Access Compliance Report Public Rights-of-Way (Curb Ramps)

Main Street: STERLING_GLEN Cross Street: SNAPDRAGON_ST Location: SE

ADA ID: RPRK211029144749 Ramp Type: Type 4 - Parallel Initial Pass/Fail: Fail Overall Compliance: No Severity Score: 16

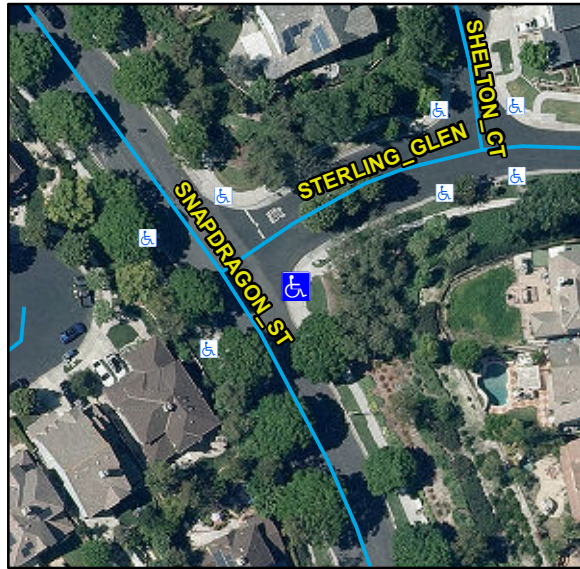
R204.3, R304.3.2, R304.5.3, STD 1115

Compliance	Description	Data	Compliance	Description	Data
N/A	Ramp Length LT (in)	131	N/A	Ramp Length RT (in)	130
Yes	Ramp Width LT (in)	88	Yes	Ramp Width RT (in)	88
No	Ramp Run Slope LT (%)	8.4	Yes	Ramp Run Slope RT (%)	0.2
Yes	Ramp Cross Slope LT (%)	0.2	No	Ramp Cross Slope RT (%)	2.5
N/A	Landing Present	N/A	N/A	DWS Provided	N/A
N/A	Landing Length (in)	N/A	N/A	DWS Contrast	N/A
N/A	Landing Width (in)	N/A	N/A	DWS Length (in)	N/A
N/A	Landing Run Slope (%)	N/A	N/A	DWS Full Width	N/A
N/A	Landing Cross Slope (%)	N/A		DWS Offset Type	N/A
N/A	Landing Movement Obstructed?	N/A	N/A	DWS Offset Left (in)	N/A
	Landing Movement Type	N/A	N/A	DWS Offset Right (in)	N/A
N/A	Landing Shared	N/A			
N/A	Clear Space	Yes			
N/A	Clear Space To Crosswalk (in)	N/A			
N/A	Marked Crosswalk 1	No	N/A	Marked Crosswalk 2	No
	Crossing 1 Direction	N		Crossing 2 Direction	W
	Marked Crosswalk 1 Width (in)	N/A		Marked Crosswalk 2 Width (in)	N/A

Remove & Replace Curb Ramp With Two New Directional Ramps or Equivalent.
